Interactive comment on “Applying SWAT to predict orthophosphate loads and trophic status in four reservoirs in the upper Olifants catchment, South Africa” by J. M. Dabrowski

Author Response to Reviewer 1:

Fig. 1. Revised version of figure 4

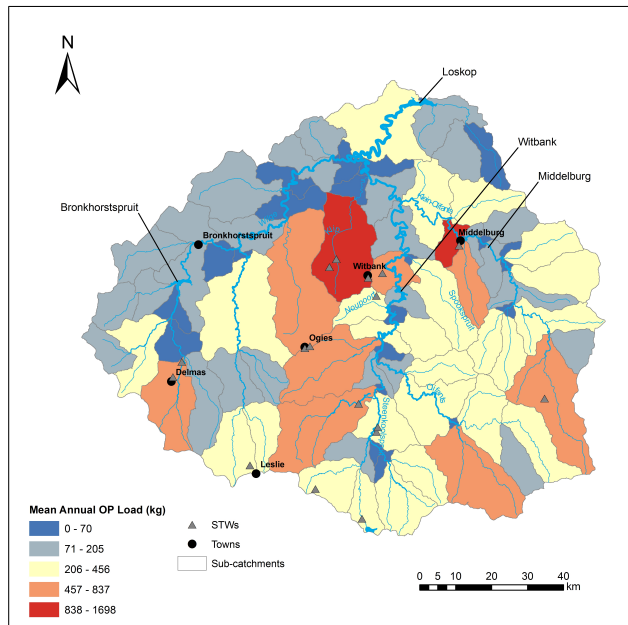
Figure 4: The actual figure and the figure caption have been updated as per the reviewers comments.

Page 1346, Line 28: The map has been revised to indicate mean annual OP loads generated per sub-catchment (as opposed to accumulated loads from upstream to downstream). This has the effect of clearly identifying which sub-catchments are responsible for generating high OP loads.
